Facility Name: City of Meadow Landfill

Permit or Registration No.: MSW-2293C

Re: Response to Technical Second Notice of Deficiency Letter
City of Meadow Landfill
Meadow, Terry County, Texas
Municipal Solid Waste Permit Number: 2293C
Tracking No. 30060987; RN101570976/CN606025534
Major Permit Amendment

City of Meadow Landfill, Permit No. 2293C, Second Technical Notice of Deficiency

MAJOR PERMIT AMENDMENT ASOS WIND ROSE		
CITY OF MEADOW LANDFILL TERRY COUNTY, TEXAS		
 Weaver Consultants Group TBPE REGISTRATION NO. F-3727		
DRAWN BY: RAA	DATE: 06/2025	FILE: 0120-809-11
REVIEWED BY: JBM	CAD: 1/11-4-2C WIND ROSE.DWG	FIGURE 1/11-4.2C

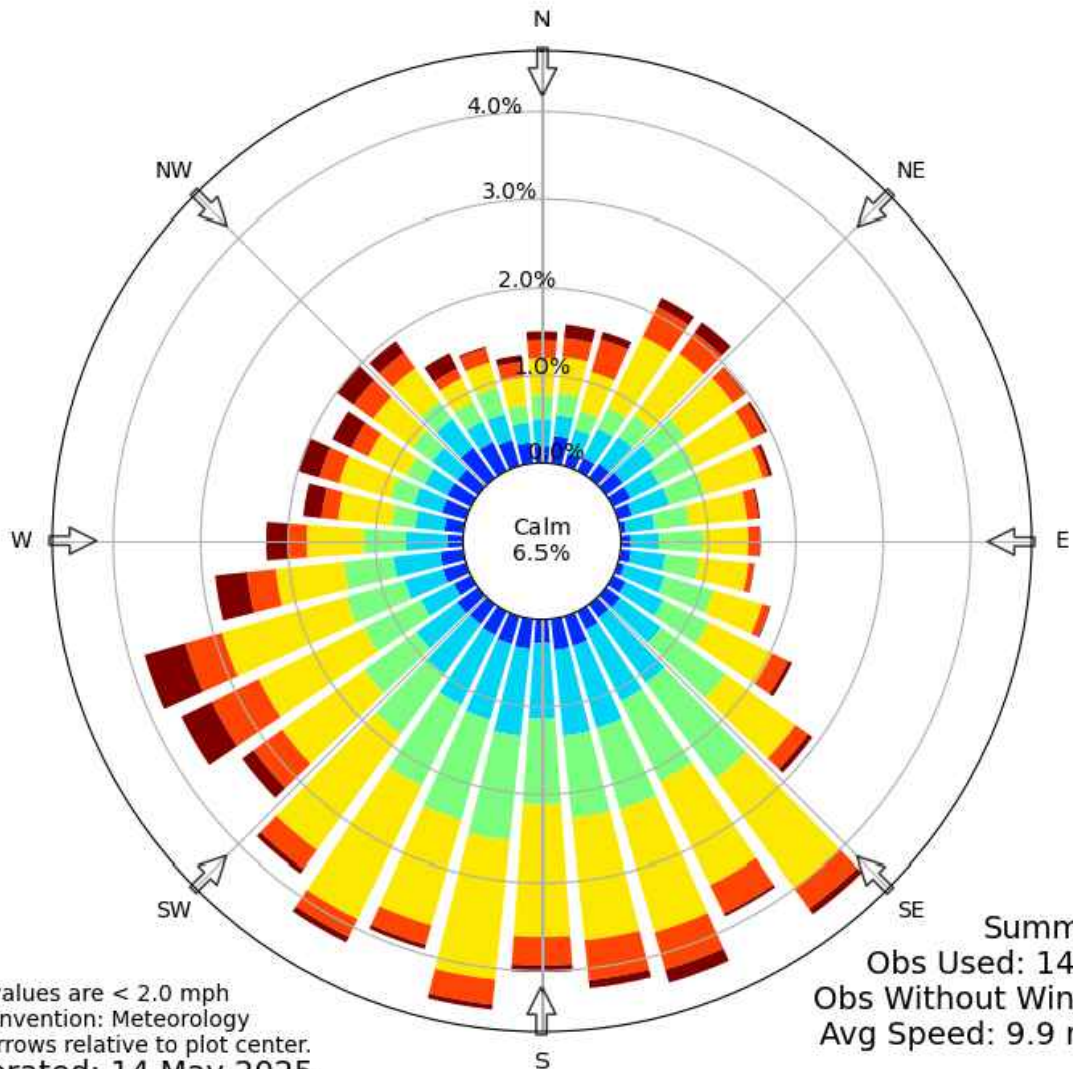
13	14	Part III, Appendix IIII, Form 20723	330.57(d)	The post-closure component costs presented in Part IV are larger than those presented on the following Table 1 and on Table 2 (page IIII-12). Verify and correct. Response: The post-closure cost presented in Part IV of Form 20723 included the cost for the 30 year post-closure period. These costs have been revised to match the costs provided in Table 2 - Post-Closure Care Cost.
14	171	Part I/II, Figure I/II-4.2A	330.61(c)(1)	Multiple points of data are needed for a more confident determination of prevailing wind direction. Provide two more wind roses from the next nearest meteorological stations apart from Levelland, as well as the original wind rose based on data from the Lubbock airport. Provide each wind rose on a separate page. Response: Figures I/II-4.2B and I/II-4.2C have been added to depict wind roses from Lubbock and Denver City airports.

SHEET I/IIA-1

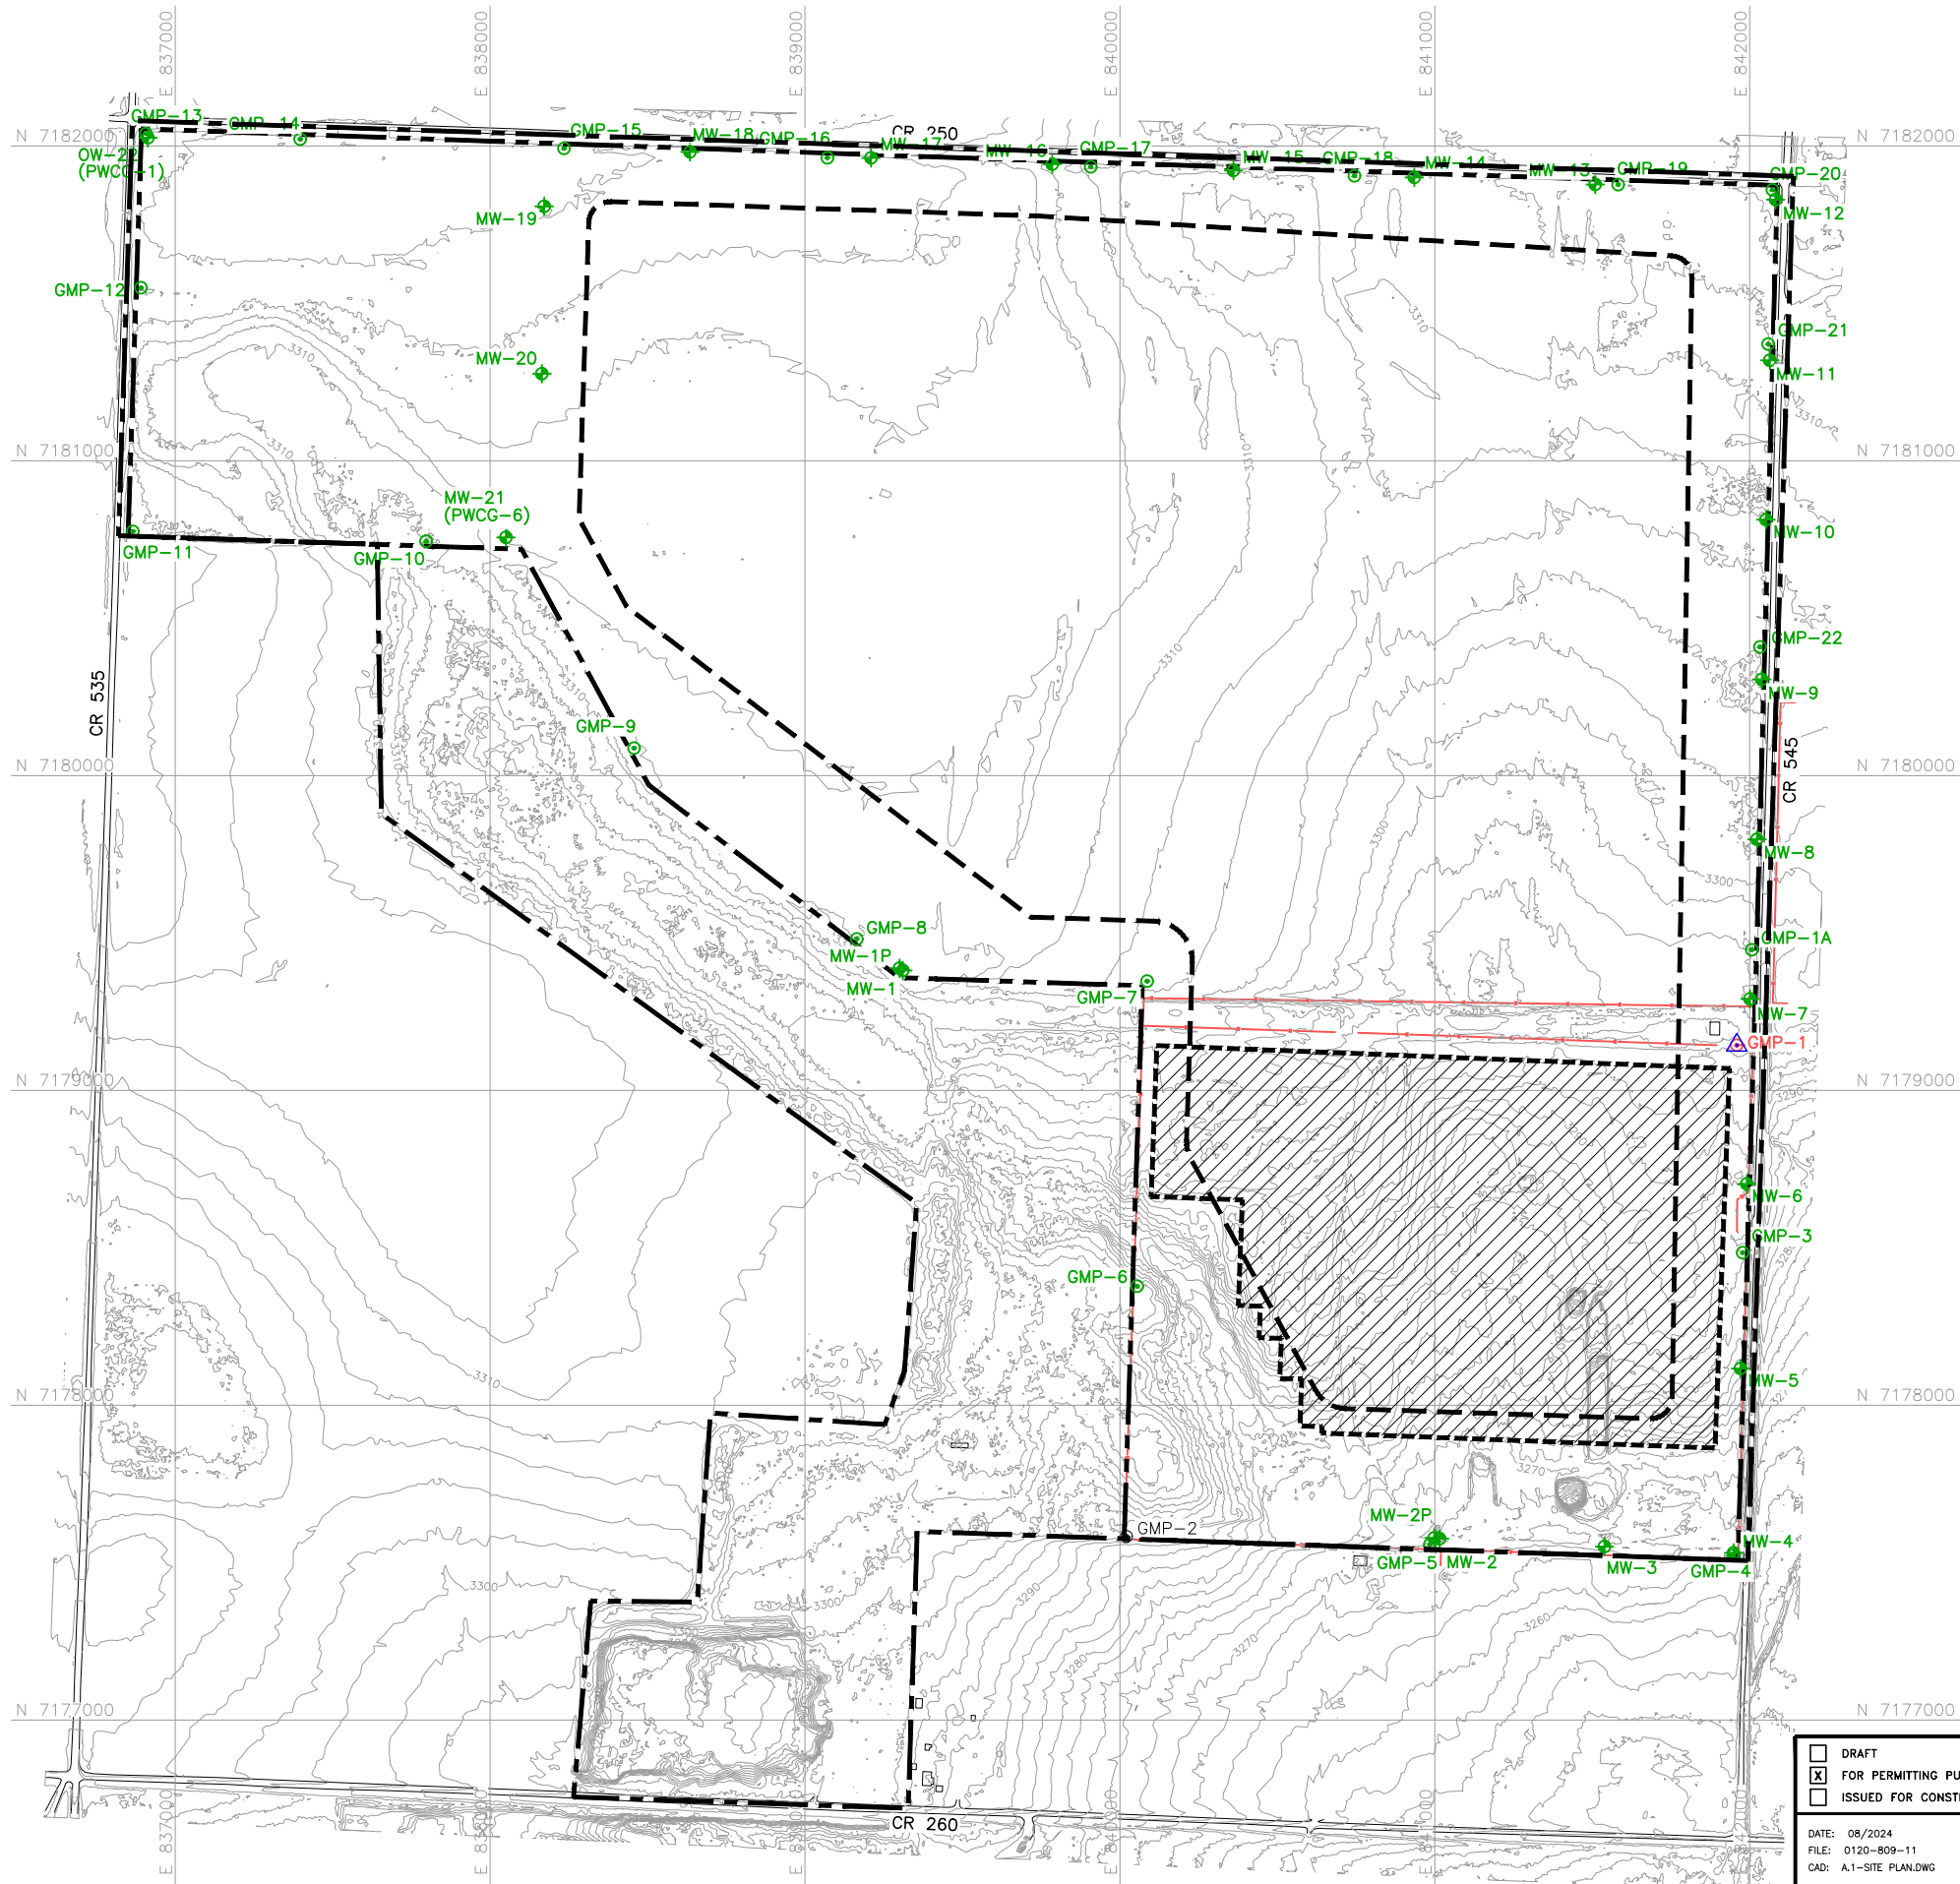
8	12	Part I/II, Appendix I/IIA, Figure I/IIA.1	330.57(d)	The coordinates presented on the figure seem different from the benchmark location when plotted on a map. Note that the site benchmark must be located within the proposed permit boundary. Provide the site benchmark coordinates in latitude and longitude format so that we may confirm the location. Response: The site benchmark information table on Drawing I/IIA.1 Site Plan has been revised to include the latitude and longitude of the site benchmark.
9	12	Part IV, Section 6.2	330.57(d)	List the other types of waste under the "other" category that may be exempt from random inspections. Response: Part IV, Section 6.2 – Load Inspection Procedures has been revised to more clearly state that loads verified through generator profiling to be free of hazardous waste and PCBs will be excluded from random inspections.
10	12	Part III, Appendix IIII, Table 1	330.57(d)	The final cover infiltration and erosion layer thicknesses specified at the top of the table are either non-existent or dozens to hundreds of feet thick. Verify and correct, if necessary. Explain why the Side Slope Cover is not used in the current closure costs. Response: Appendix IIII, Table 1 – Closure Cost has been revised to correct the infiltration and erosion layer thickness for the composite and trench area. Side Slope Cover is not used in the current closure costs because the current area is trench fill, which does not have a separate sideslope liner system.

- LIST OF REVISIONS:**
- ADDED LATITUDE AND LONGITUDE TO SITE BENCHMARK TABLE.

City of Meadow Landfill
Figure IIIJ-2 – Final Closure Schedule

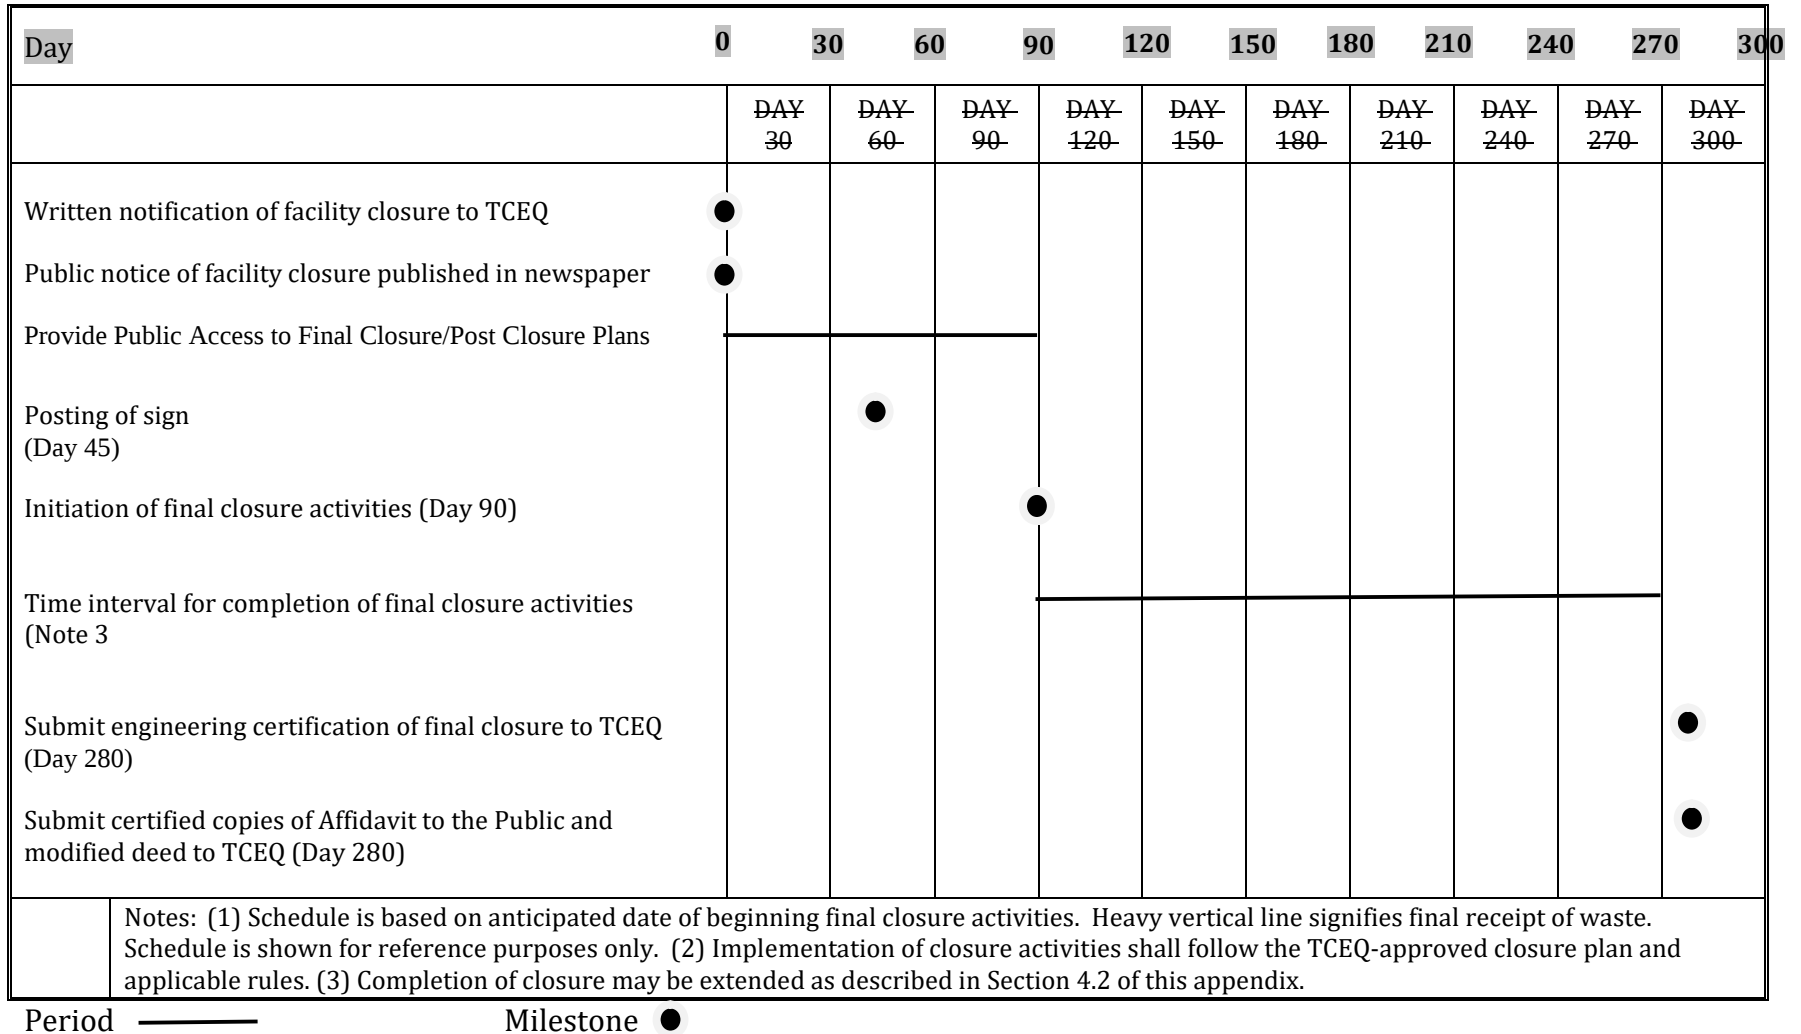
4	12	Part III, Appendix IIIJ, Figure IIIJ-2	330.57(d)	Clarify if the first vertical line on the chart represents Day 0 or Day 30. Response: Figure IIIJ-2 has been revised to clearly distinguish the lines corresponding to each day.
5	12	Part IV, Appendix IVD, Drawing 4	330.57(d)	Modify the drawing to show the bulking storage area within the containment berm, as was done with Option A. Response: Drawing 4 – Option B Liquid Waste Bulking Facility Plan has been revised to depict the bulking storage area within the containment berm. The secondary containment calculations have also been revised to account for the increased storage area footprint.
6	12	Part IV, Section 4.2.1	330.57(d)	The response to Comment 33 indicates that source-separated recyclable materials received at the Citizen Convenience Center will be stockpiled temporarily for eventual transport to an off-site recycling facility. Incorporate this understanding into the application language discussing Convenience Center operations. Response: The language from Comment 33 NOD 1 has been incorporated into Part IV, Section 4.2.1 Unloading Areas.
